Planning and Land Use Department
Planning Commission Staff Report
AMENDED for Planning Commission Meeting 10/16/25

Case Number	#2024-9320
Hearing Date	October 16, 2025
Agent	Pax Consulting
Applicant	Zydeco LLC
Request	Development Plan
Location	7205 Plaza Central, Santa Fe, NM 87507
Case Manager	Alexa Hempel
Zoning	C-1 (Office and Related Commercial)
Overlay	Suburban Archeological Review District
Pre-App Meeting	June 27, 2024
ENN Meeting	August 20 & September 30, 2024
Proposal	The Applicant requests approval of a development plan for up to 165 multi-family units with a clubhouse, swimming pool, and neighborhood coffee shop on a 7.9-acre parcel.

Case #2024-9320. 7205 Plaza Central Development Plan. Pax Consulting, Agent, for Zydeco LLC., Owner and Applicant (“Applicant”), requests approval of a Development Plan for up to 165 multifamily residential units, a clubhouse, swimming pool, and neighborhood coffee shop located at 7205 Plaza Central. The property consists of a 7.9-acre lot as the result of a future lot line adjustment, zoned C-1 (Office and Related Commercial). (Alexa Hempel Case Manager, anhempel@santafenm.gov).

Figure 2: Drawing of the new proposed exterior of one building type on the property. See full plan sets in Attachment C-11.

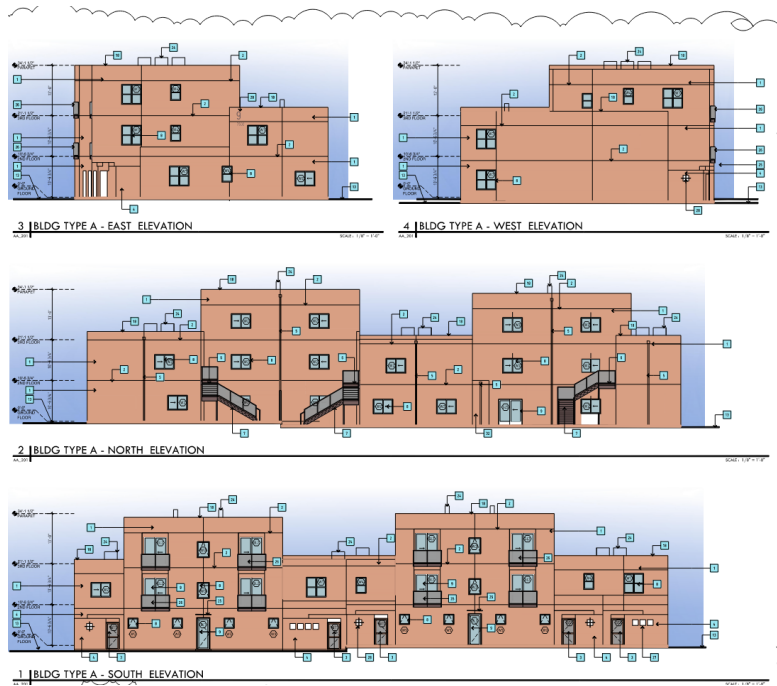
The Applicant originally proposed that the exterior stucco be painted a high-intensity colonial white with accent colors of green, gray, pink, and yellow. The Tierra Contenta Architectural Review Committee approved this proposed design, acknowledging that it deviated from the design guidelines for Phase 2C, while still meeting the intent of those guidelines. However, development plans within Tierra Contenta must go through additional City review to meet the requirements of SFCC Ch.14, which may only be interpreted by the Land Use Director after consultation with the City Attorney (SFCC 14-1.10).

SFCC 14-1.7(B) states that in the event conflicts arise between Chapter 14 and any other ordinance, resolution, or regulation, the more restrictive limitation or requirement shall prevail. In this case, Chapter 14 imposed more restrictive requirements. Staff determined that the proposed high-intensity colors did not meet the following, and therefore recommended denial for the August 7, 2025 hearing:

- Minimum 205 architectural points required for C-1 zoning;
- Development Plan Approval Criteria #3, which calls for adaptability and compatibility to properties in the vicinity; and
- Findings and Purpose of the Architectural Design Review (SFCC 14-8.7(A)), which calls for architecture outside the historic districts to maintain a degree of compatibility with architecture inside the historic districts.

Due to technological issues that led to a lack of quorum, the August 7, 2025 Planning Commission meeting was rescheduled to September 4, 2025. During that time, the Applicant changed the predominant color of the exterior stucco from colonial white to zona rosa – a terracotta color (See Figure 2). The Applicant also omitted the use of accent colors and submitted revised architectural drawings to reflect the exterior color changes (Attachment C-12).

The new design exceeds the 205 architectural points required for C-1 zoning and is compatible with the surrounding neighborhood as well as the architecture found within the City's historic districts. Staff are now recommending approval as the application meets the required architectural points, development plan approval criteria #3, and the purpose of the architectural review guidelines.

Figure 3: Zorro Blanco Pedestrian, Bicycle, Vehicular Plan

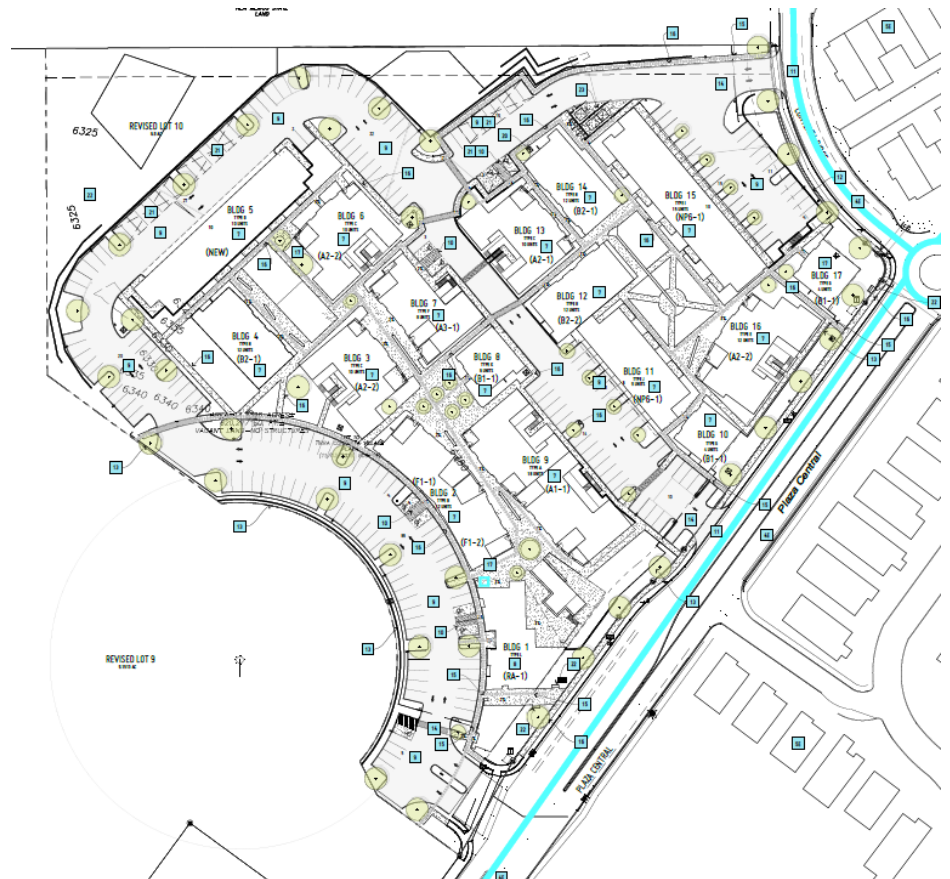
These results indicate that the area intersections will function effectively, with LOS A and B being classified as well-operating conditions. As requested by the Metropolitan Planning Organization and supported in the Traffic Impact Analysis, the right-turn lane off Plaza Central will be the shortest necessary length at 250 feet. The TIA does not recommend any roadway design revisions. Conditions of Approval and Technical Review comments can be found in Attachment A.
